Project Name:	Proposed Residential Development, Hemingfield, Barnsley				
Client:	Hargreaves Land Limited				
Subject:	Technical Note - Response to Highways Consultation Comments				
BGH Reference:	23-160-004.04				
Date:	22 nd August 2024				
Prepared by:	P Pitcher	Checked by:	R Donaldson	Overview by:	S Wilkins

HIGHWAYS DEVELOPMENT CONTROL
CONSULTATION RESPONSE

Stage 1 Road Safety Audit

Stage 1 Road Safety Audit Designer's Response

Drawing No: 23/160/ATR/003

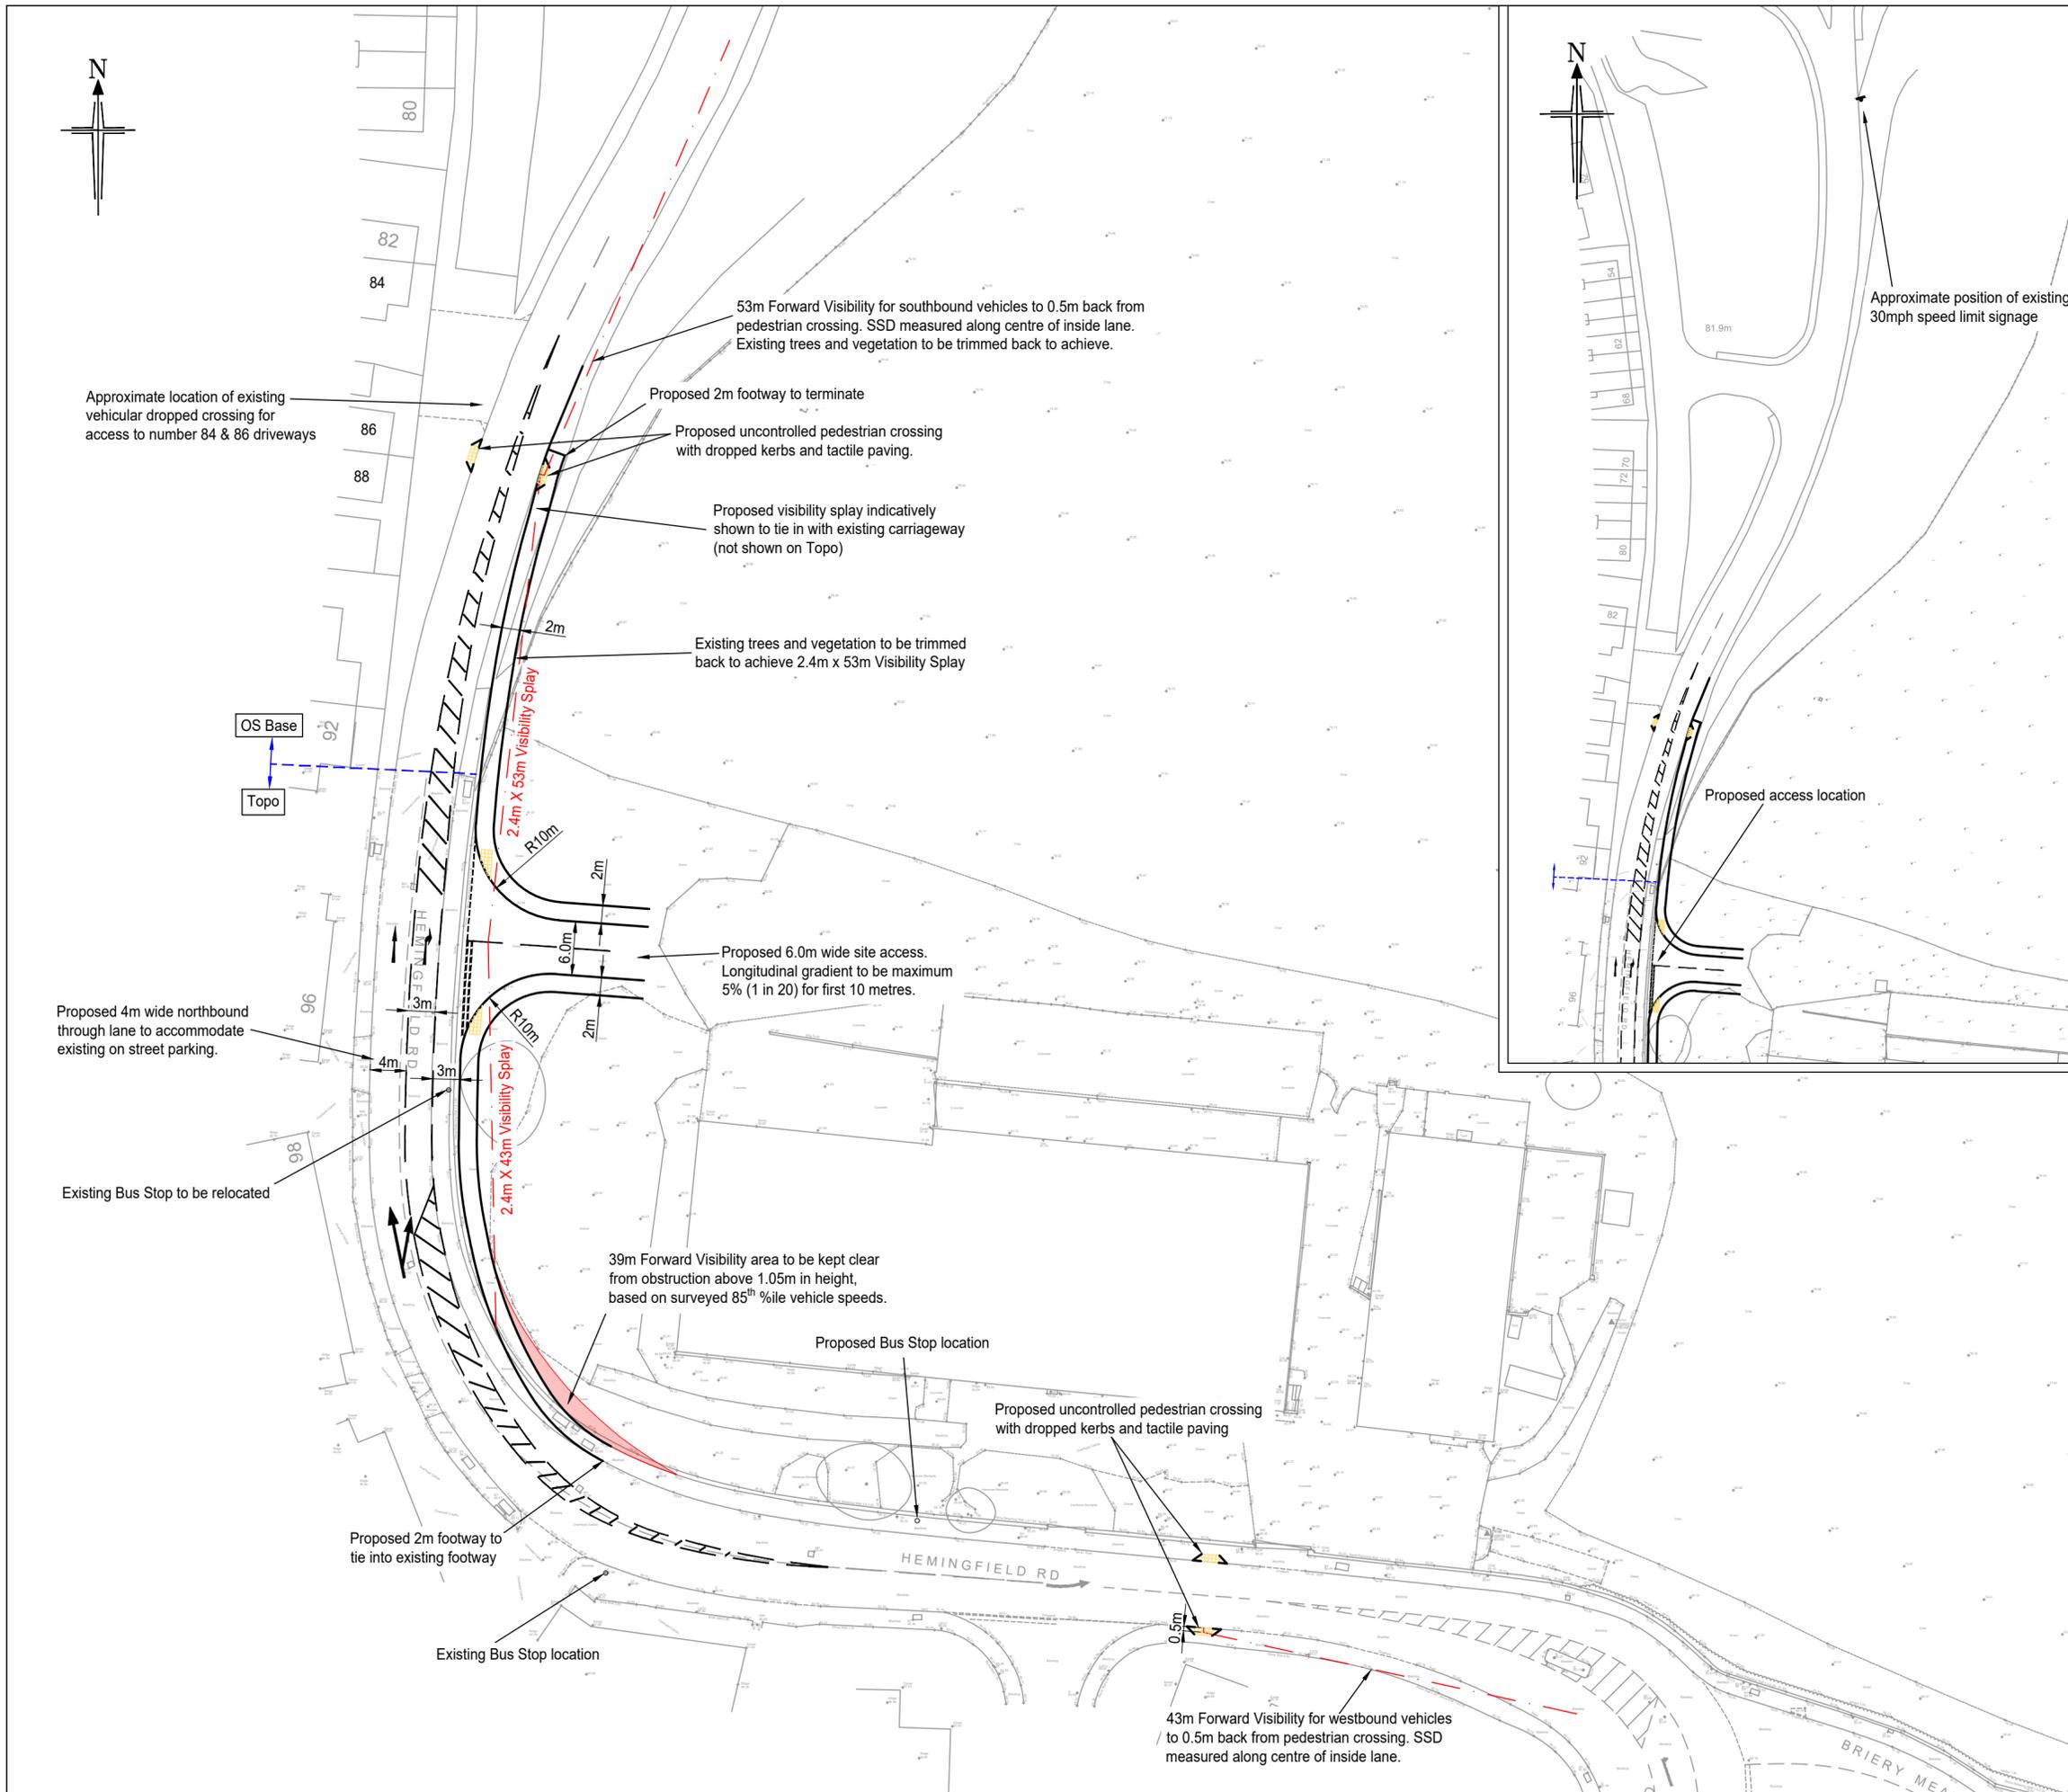
Problem H				
Hemingfield Road southbound through lane width.	It is recommended the southbound movement through the junction is assessed further to ensure that large vehicles including buses can pass through	Swept path analysis of a single deck bus and a 16.5 metre articulated HGV travelling southbound along Hemingfield Road has been undertaken, as shown on drawing number 23/160/ATR/003 Rev A at Appendix BGH2 .

Drawing No: 23/160/ATR/001

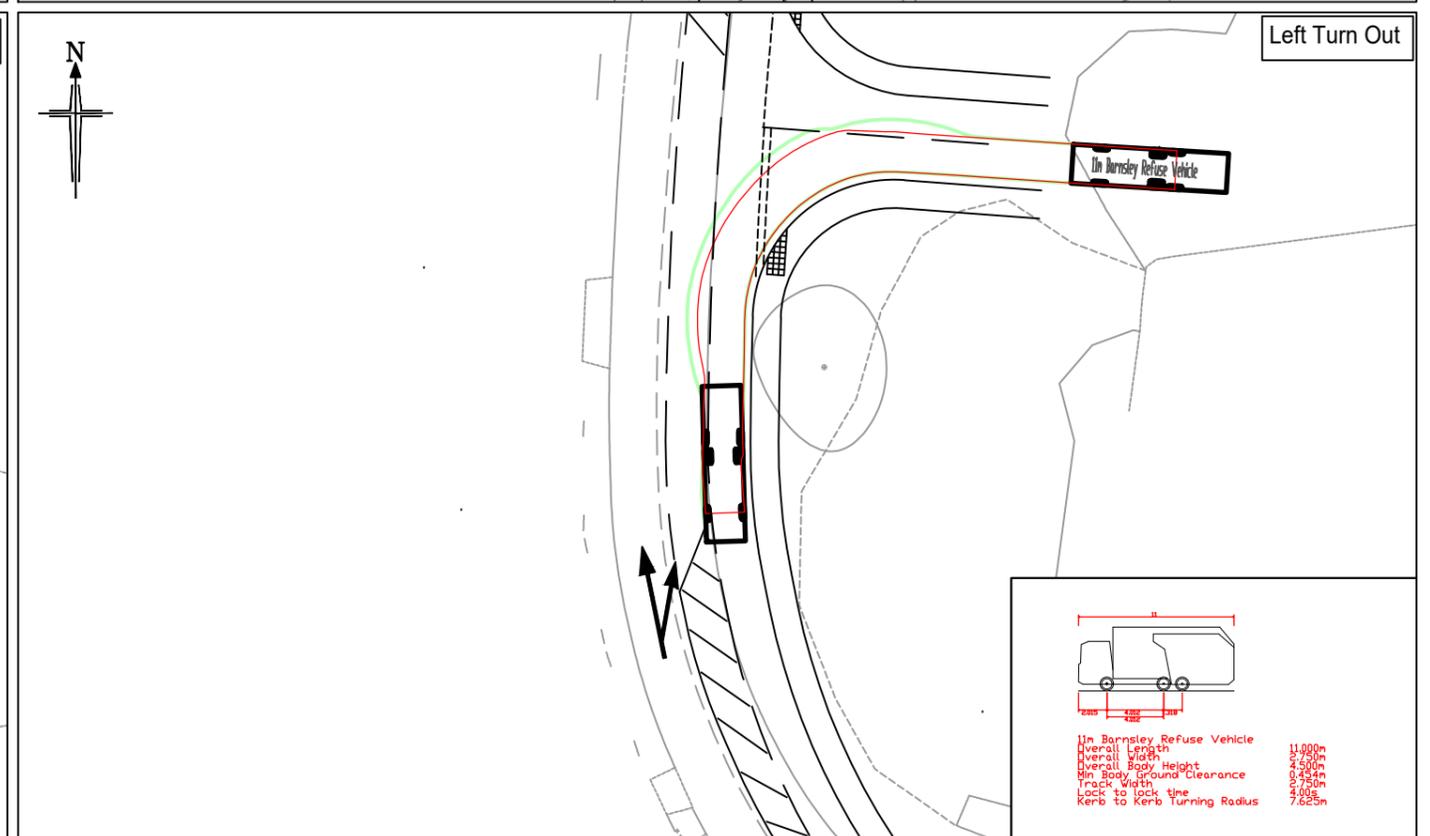
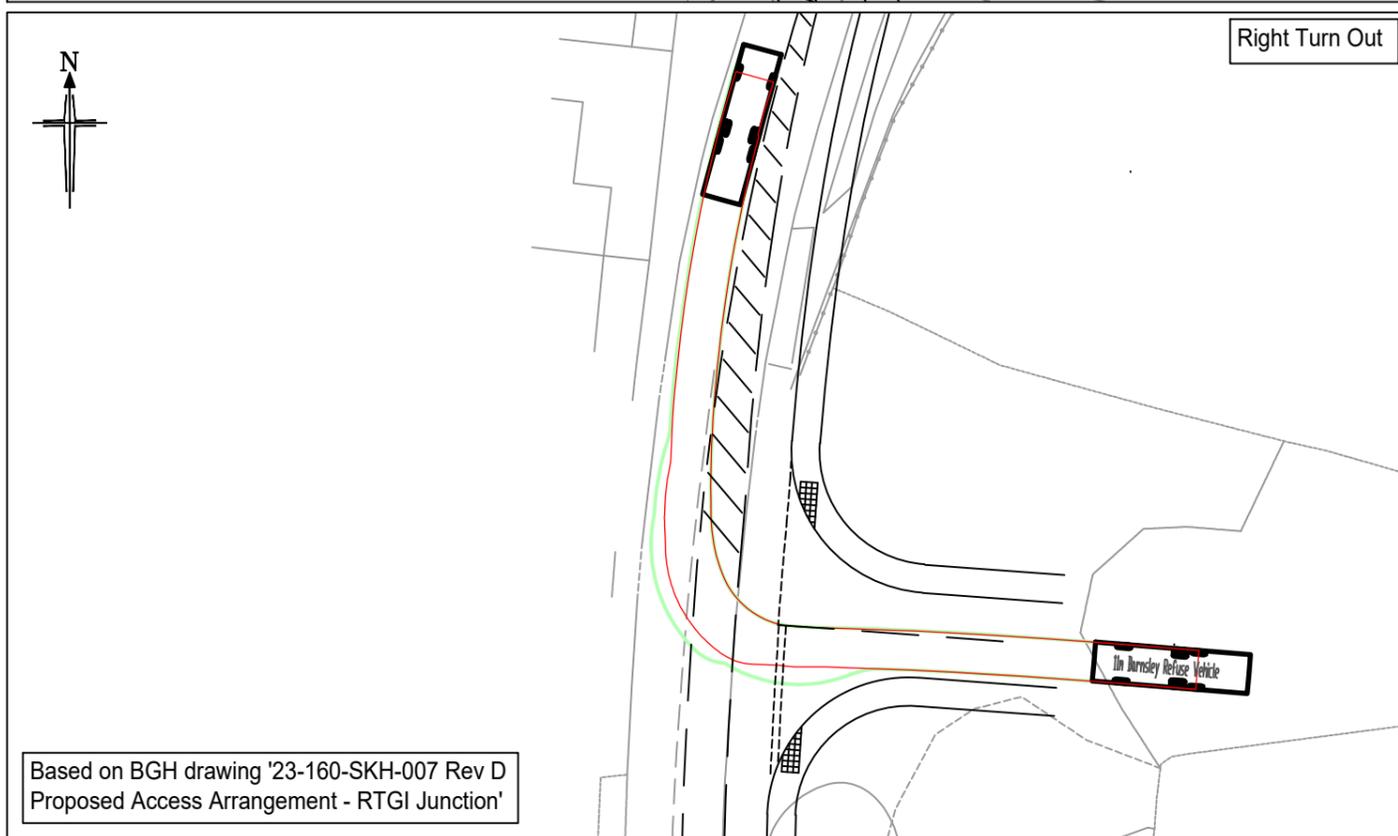
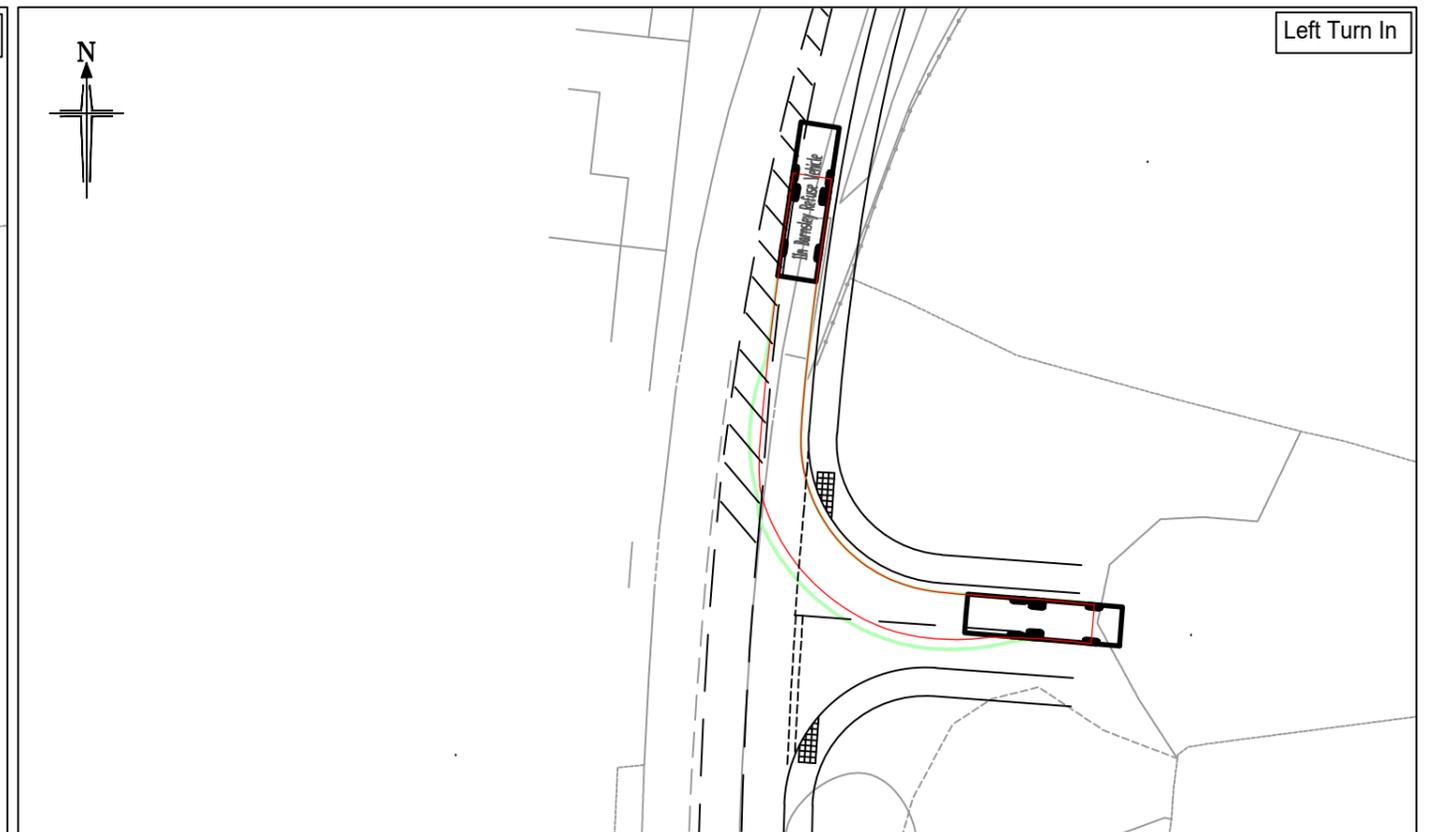
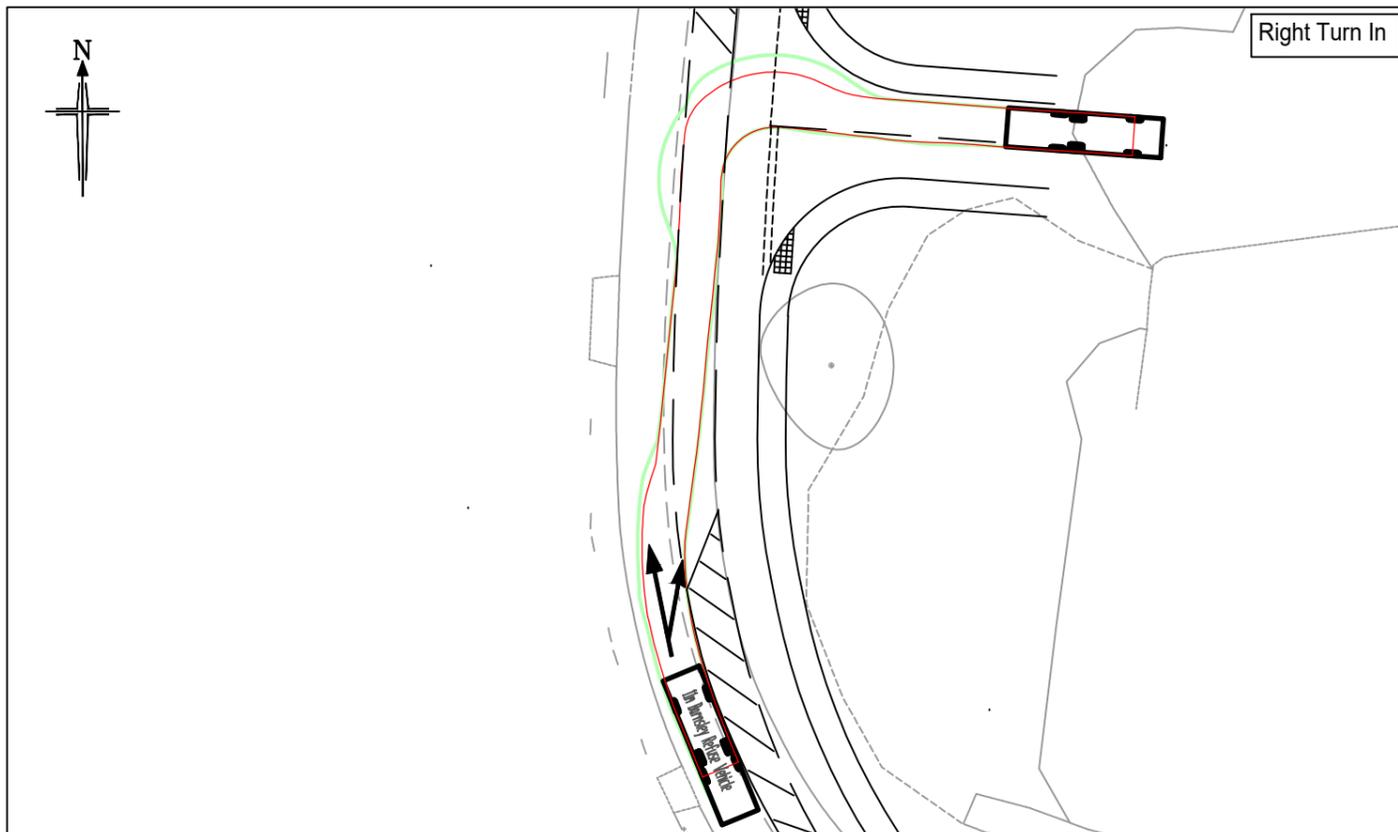
As mentioned in the pre-application response 2023/ENQ/00437, the refuse vehicle that requires tracking is as follows: Length 11 metres, width 2.75 metres, height 4.5 metres, weight 26 tonnes, turning circle needed 15.25 metres. A 0.5m gap from the edge of the carriageway or other obstruction should be maintained at all times when tracking vehicles. The tracking should therefore be updated.

37. The refuse vehicle swept path analysis has been updated to reflect the specified vehicle measurements and this is attached at **Appendix BGH8** (23/160/ATR/001 Rev D). A 0.5 metre wide gap between the vehicle and the edge of the carriageway has been maintained when tracking the vehicle as requested by BMBC. The drawing shows that a refuse vehicle of this size can access and egress the site from Hemingfield Road, at the proposed site access junction.

46. The refuse vehicle swept path analysis of the proposed site access has been updated to reflect updated vehicle dimensions provided by BMBC Highways DC, and to show a 0.5 metre wide gap between the vehicle and the edge of the carriageway. The swept path analysis confirms that a refuse vehicle of this size can access and egress the site from/to Hemingfield Road, at the proposed site access junction.
